8MR151

sensors board schematic

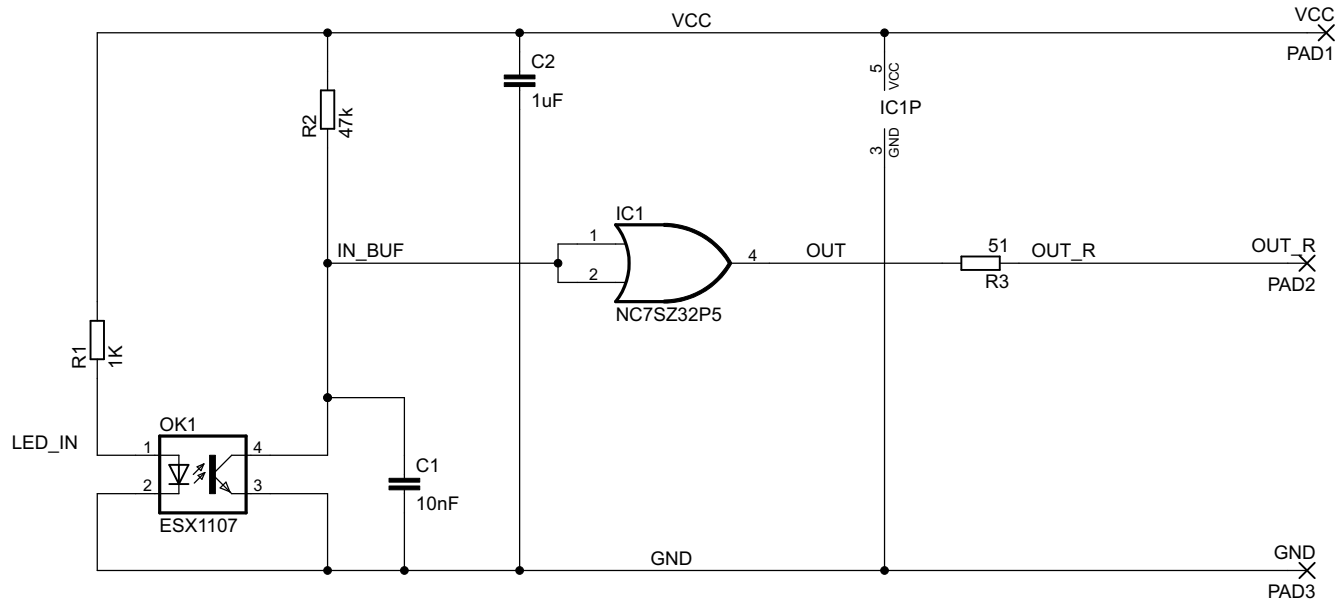
This schematic is valid from 2008 year autumn.

Before this date the schematic did not contain amplifier and related elements (IC1, C1, C2, R2, R3)

IC of type NC7SZ32P5 allowable to change to NC7SZ08P5, SN74LVC1G08DCKR, SN74LVC1G32DCKR without functionality change.

On special order IC of type NC7SZ32P5 can be changed to NC7SZ04P5, NC7SZ14P5, SN74LVC1G04DCKR or SN74LVC1G14DCKR with inversion of output logic.

Note: some quantity of boards where produced with pin 1 of IC1 not wired. During assembling or repair pin 1 must be soldered to pin 2 manually.
